Instream Flow Study of the Lower San Antonio River and Lower Cibolo Creek

Study Design

Prepared by
***TEXAS INSTREAM FLOW PROGRAM
AND SAN ANTONIO RIVER AUTHORITY***

MARCH 2012

Figure 14. Stages of stakeholder participation in lower San Antonio River sub-basin study.

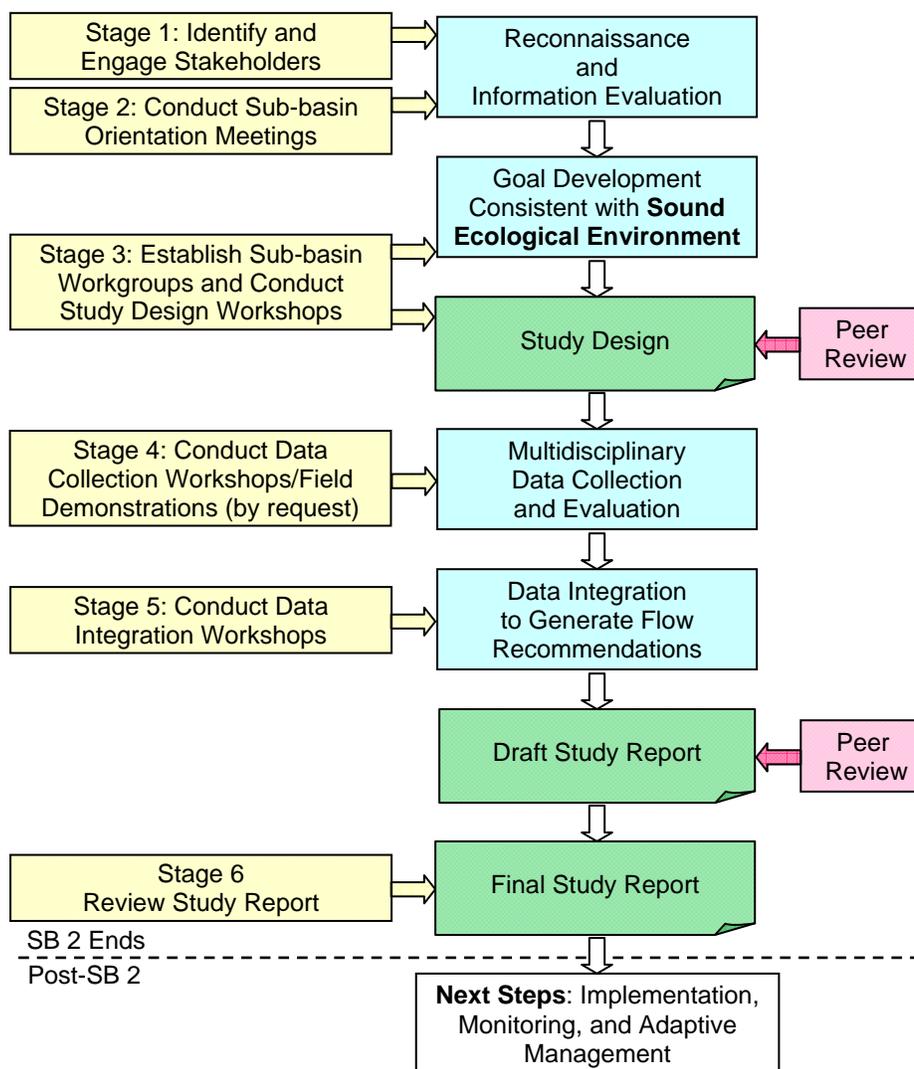
Comment 19 - The importance of stakeholder participation, input and buy-in cannot be overemphasized. It is not clear from the discussion in Section 4.0 or the diagram in Figure 14 how this is to be accomplished for the Study. Annual presentations seem too infrequent to allow for useful input from the stakeholders.

described in the study plan. Figure 14 in section 4.0 of the study plan shows a flow chart that includes development and review of a final report. Without proper planning to document all of the intermediate, multidisciplinary data collection and evaluation tasks, the final report (and peer review of a final report) is likely to be based on inadequately documented and reviewed data collection and analysis.
